Sandia National Laboratories

subject: Response to NMED Request for Information on the Mixed Waste Landfill

Per your request of December 18, I have prepared the following responses to the information request by Will Moats:

**MIXED WASTE LANDFILL
MONITOR WELL LOCATIONS**

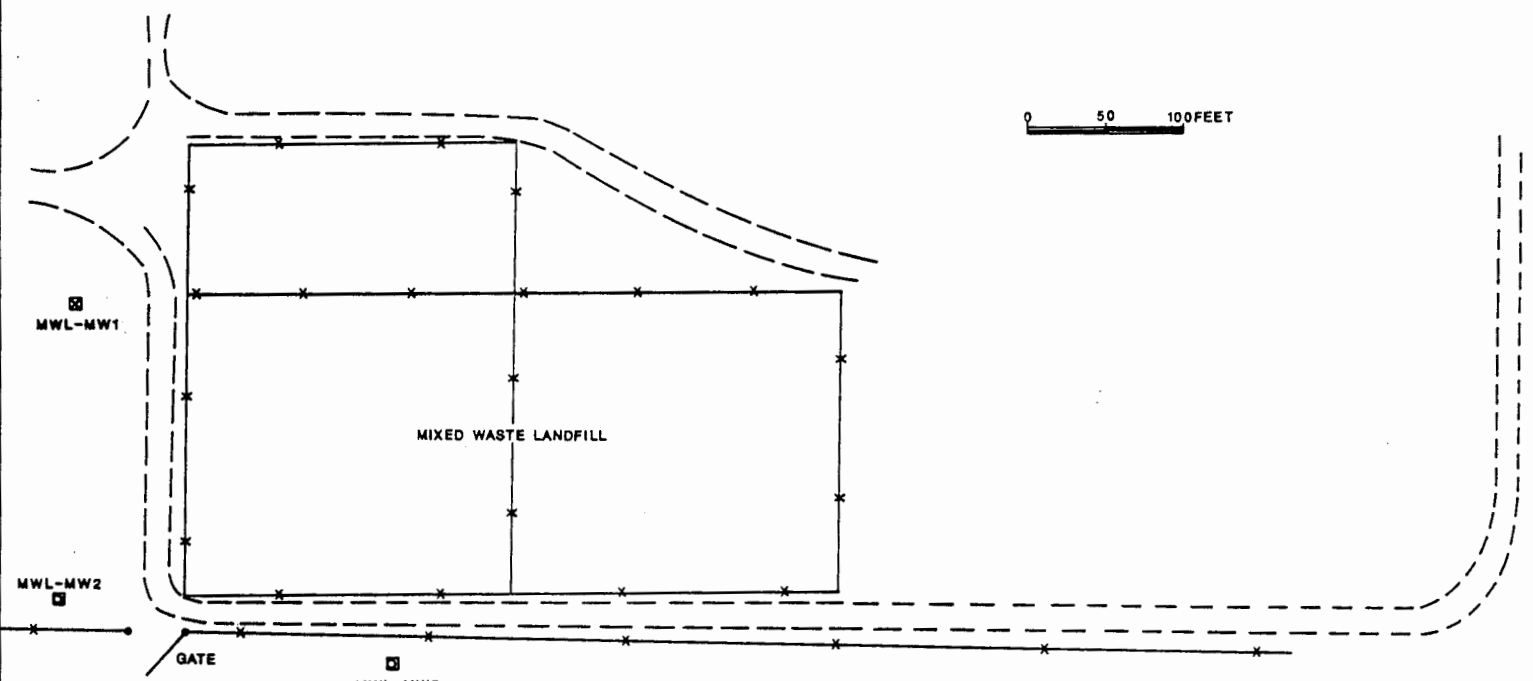
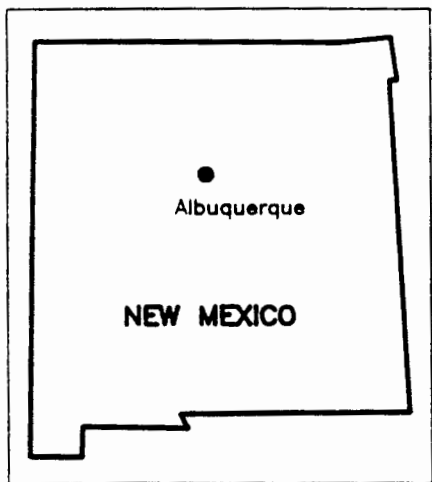
Item 1 - Comment: Provide detailed site maps showing boundaries, survey control points, topography, road Access, and the locations of all monitor wells, test pits, and soil borings.

Response: Please see the attached. Much of the requested information will be included in the final RFI report which will be produced upon completion of the Phase II RFI.

Figure 3-4: SOIL BORING LOCATIONS AT MWL

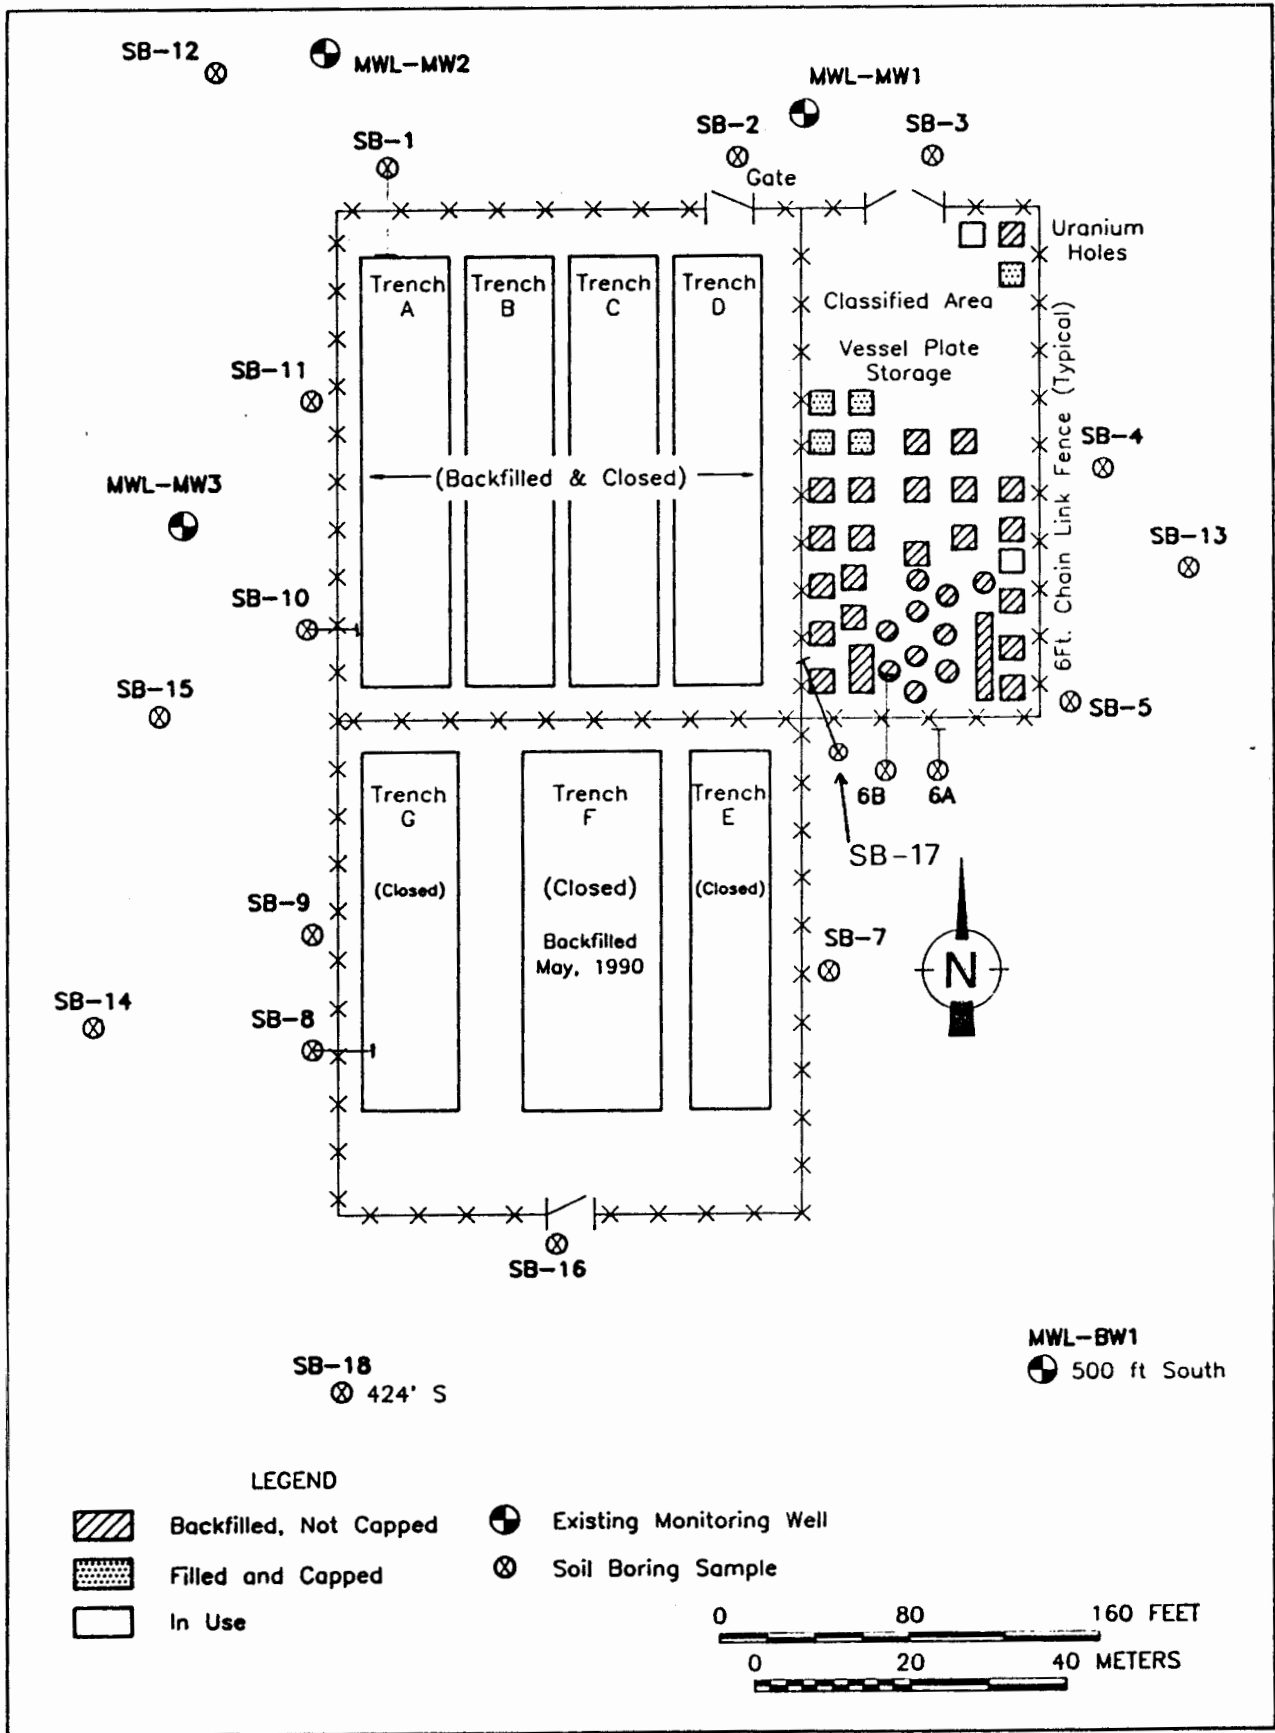
Item 9 - Comment: List all soil borings and test pits at the MWL

Response: see attached.
